TECHNICAL SERVICE BULLETIN

Charging System Fault Message In The Instrument Panel Cluster - Mud Accumulation In Generator

22-2392

Ford 2021-2022 Bronco

Figure 1

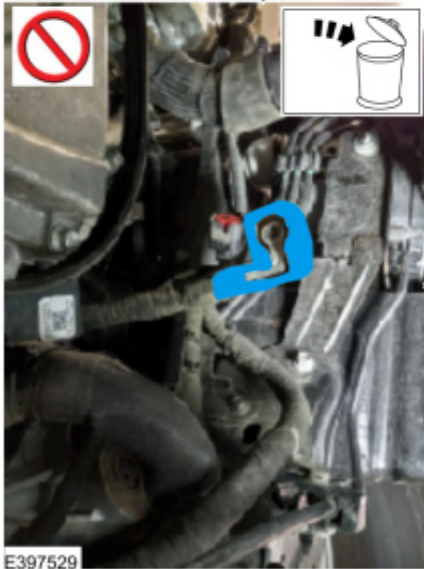
1. Replace the generator, refer to Workshop Manual (WSM), Section 414-02. During replacement, replace the generator shield with the new version.
2. For 2.3L only, during generator replacement, while the B+ connector is disconnected, cut off and discard the rubber protective boot which covers the B+ wire connector. (Figure 1)
